DRAINAGE LETTER

HOPE PHYSICAL THERAPY

March 31, 2023

PCD File No. PPR235

Water Surface Profile Plot for Culvert: Culvert 1

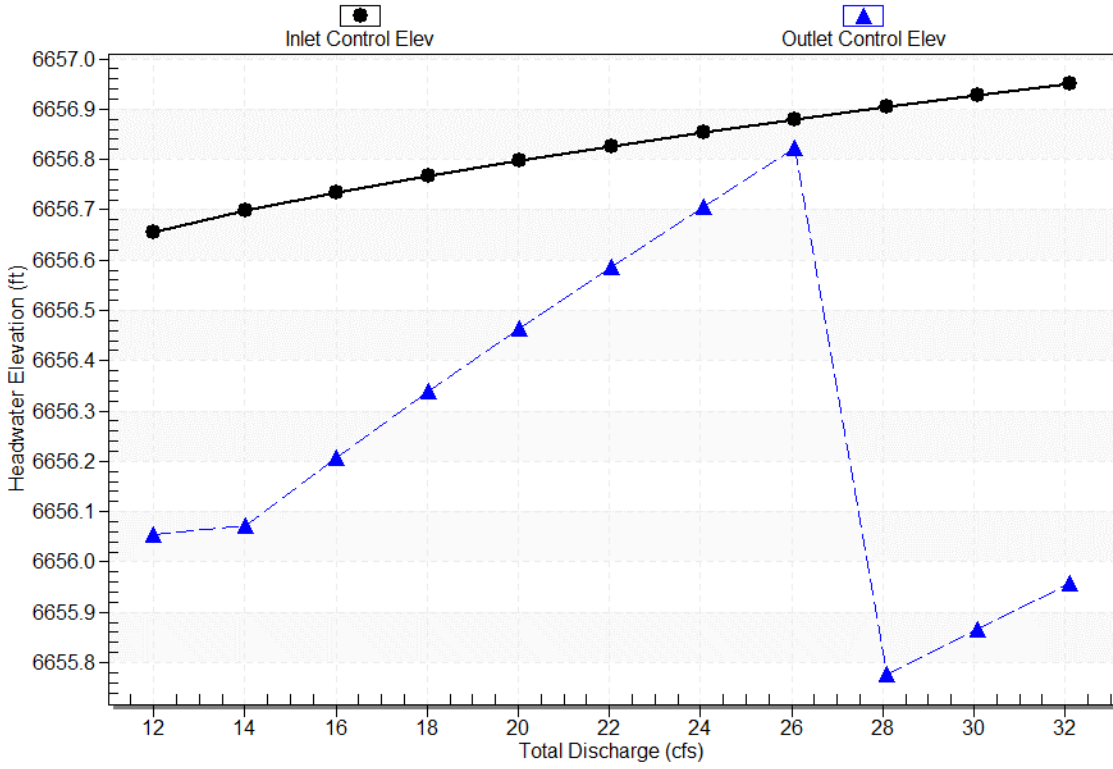
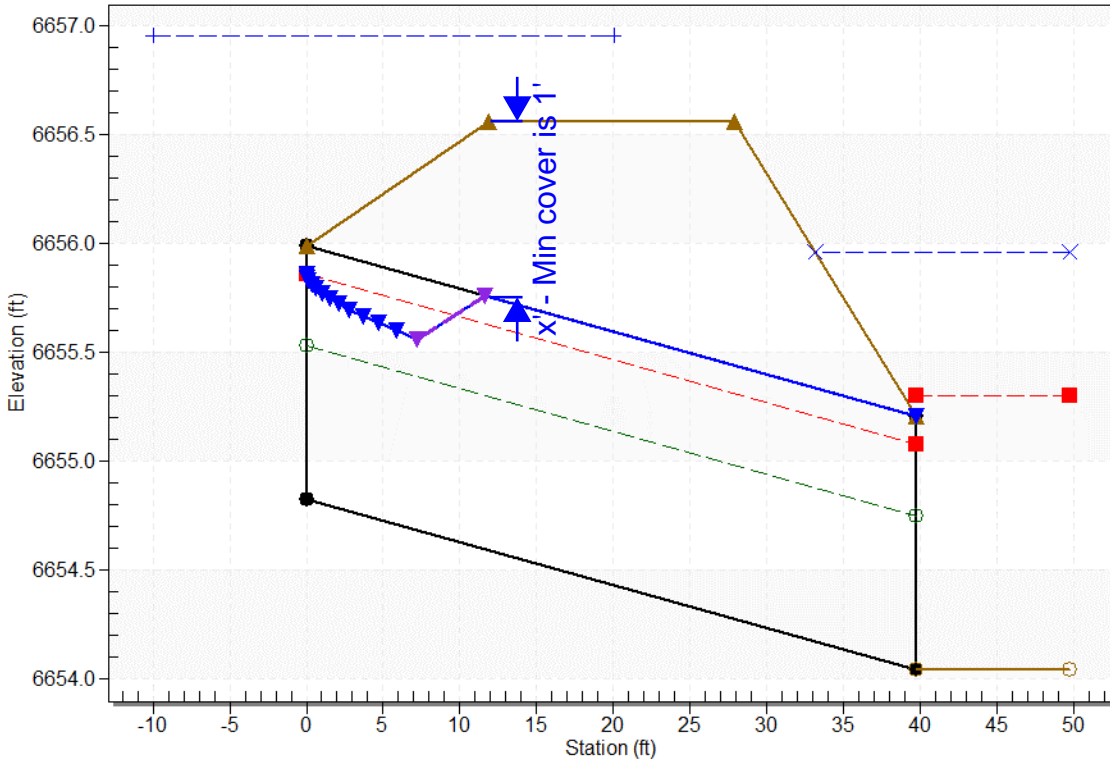
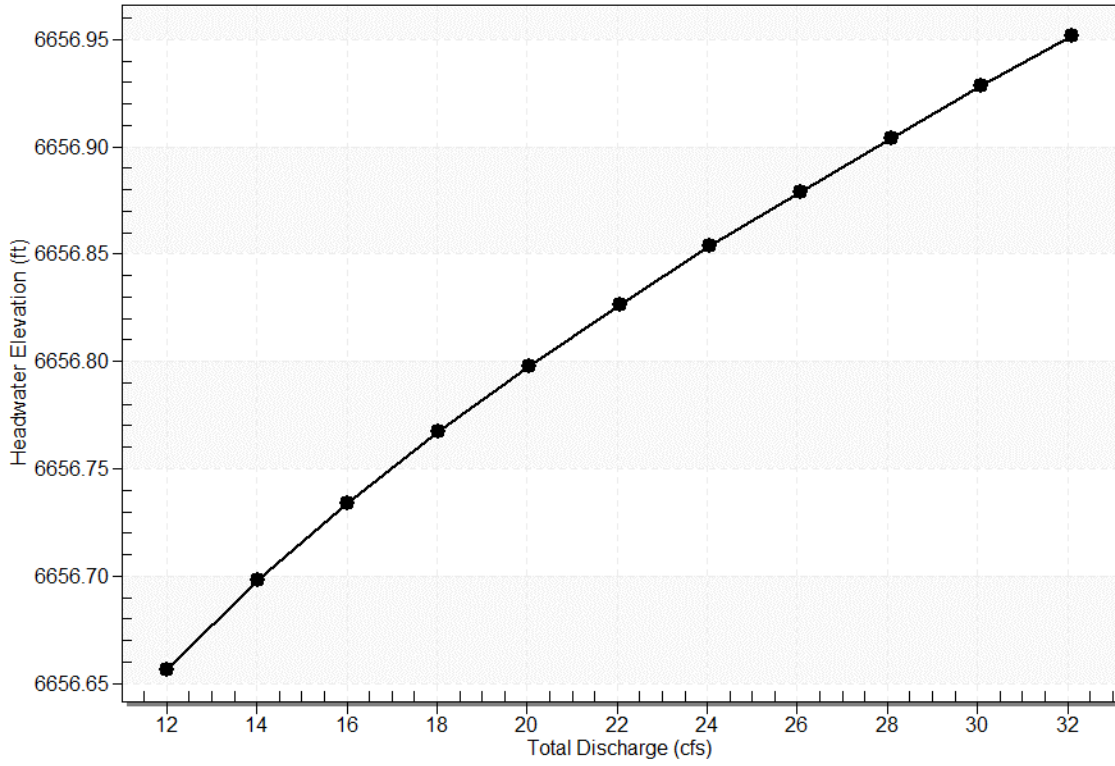
Provide calculations for:

- Concrete pan
- Proposed swale, prior to existing structure
- Existing swale exiting proposed culvert
- Existing inlet/structure with proposed flow, to show adequacy
